Subject: Docket Number 070-03098
Shaw AREVA MOX Services
Mixed Oxide Fuel Fabrication Facility
Submittal of Revision 7 of the MOX Project Quality Assurance Plan

MOX Project
Quality Assurance Plan

Revision 7

Figure 1-1: MOX Services Functional Organization

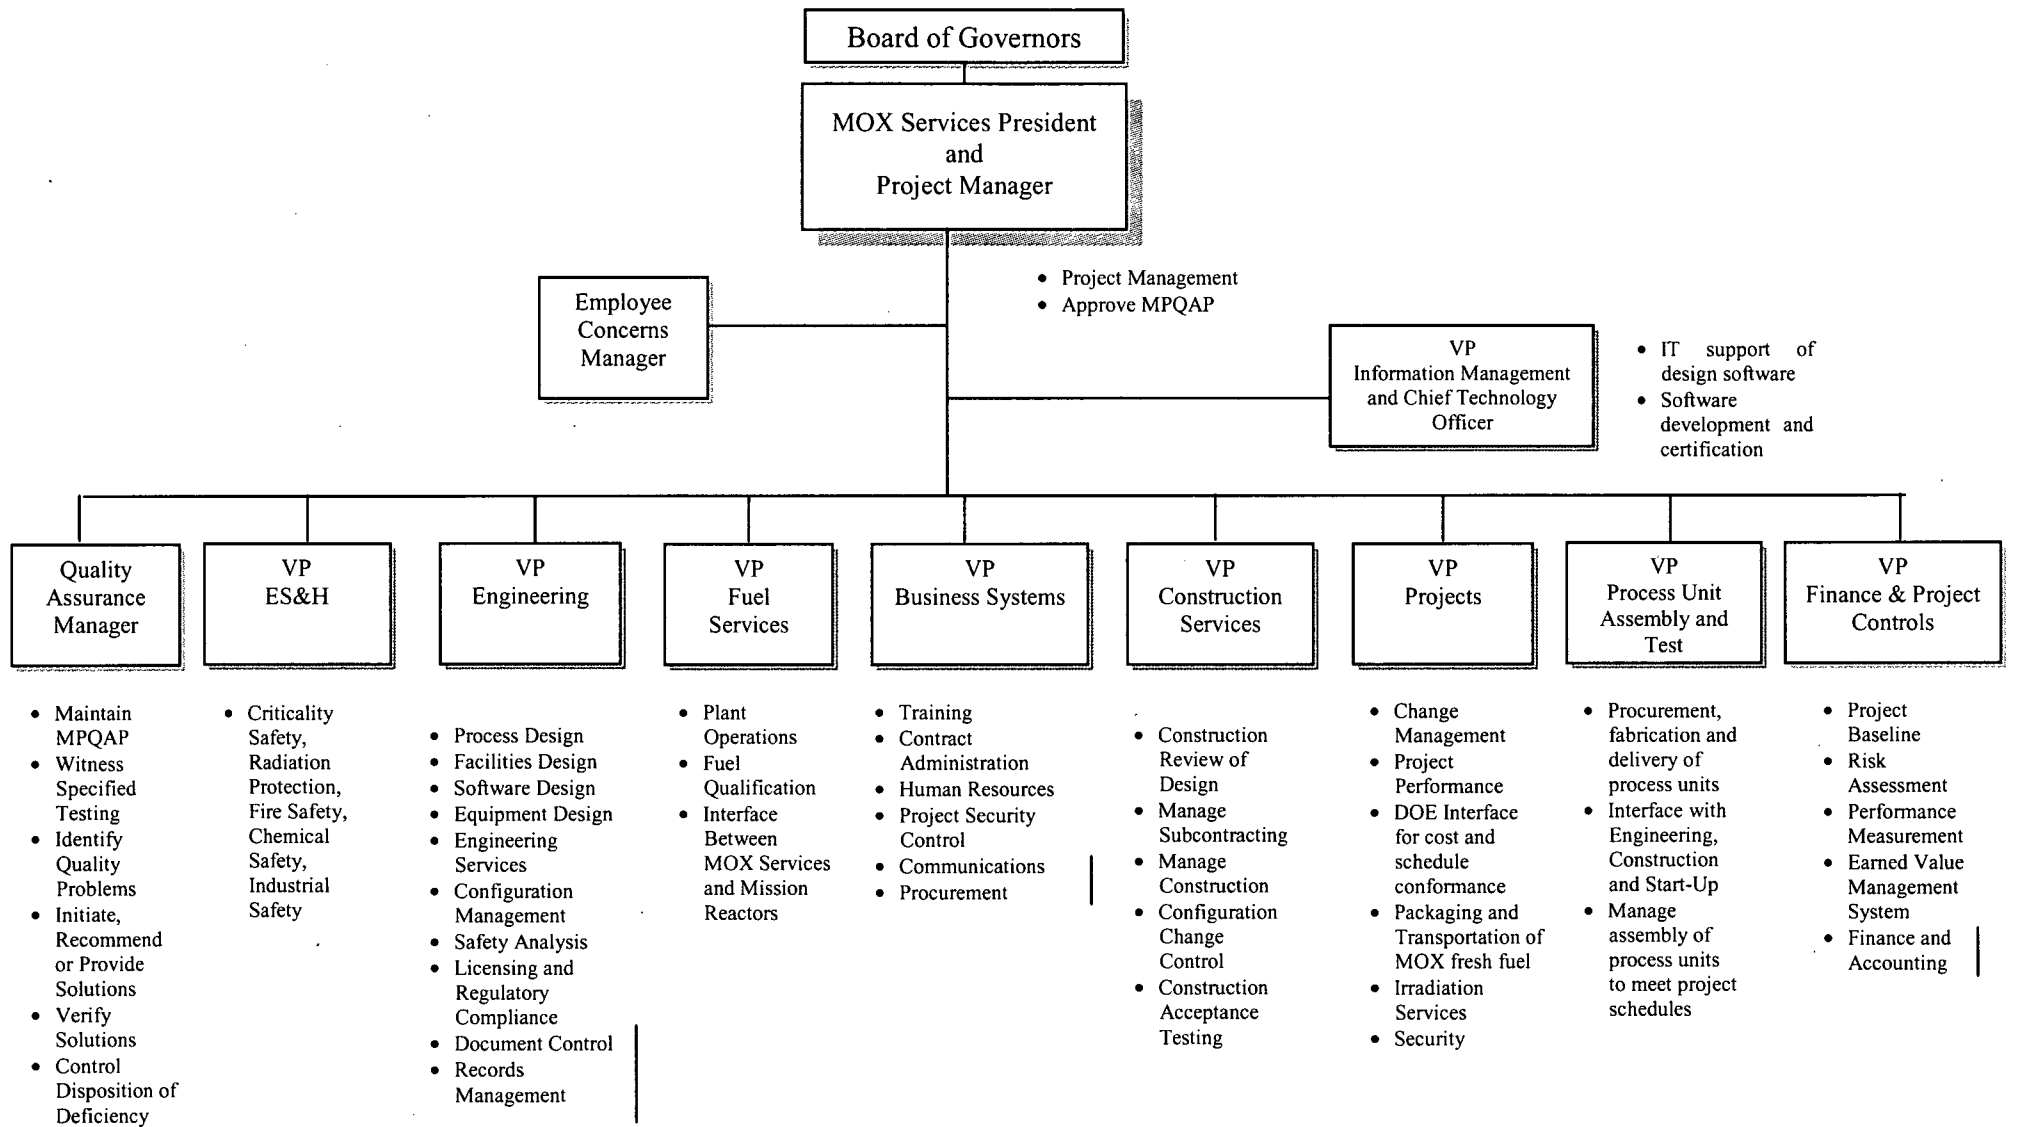
MPQAP SECTION	DESCRIPTION OF CHANGE IN REVISION 7
Section 1	• Section 1.2.2, changed "Internal Assessments Manager" to "Audits Manager", the responsibilities of this position remained unchanged. • Section 1.2.2, deleted "and Receipt Inspection" from the 5th sentence. This function was changed from the Supplier Quality Manager to the Quality Control Manager. Figure 1-2 was revised to include this function under the Quality Control Manager. • Section 1.2.2, Changed the term "surveillance" in two places to "monitoring of activities" to clarify that this activity is not related to Technical Specification surveillances or those supplier surveillances required by ASME/NQA-1, Section 7, Control of Purchased Items and Services. A definition of monitor was added for clarification. Figure 1-2 was also revised to reflect this change. • Section 1.2.4, added the last paragraph to describe the Document Control function (includes record management) which is added to the responsibilities of the VP Engineering. Figure 1-1 was also changed to reflect this change. • Section 1.2.6 was revised to change the title "Vice President and Chief Administrative Officer" to "Vice President Business Systems" and changed responsibilities. Deleted document control, records management, finance and accounting, and facilities management functions. Added the communications function. Figure 1-1 was also revised to reflect these changes. • Section 1.2.9, changed the title from "Vice President Project Controls" to "Vice President Finance and Project Controls". Figure 1-1 was revised to reflect this change.
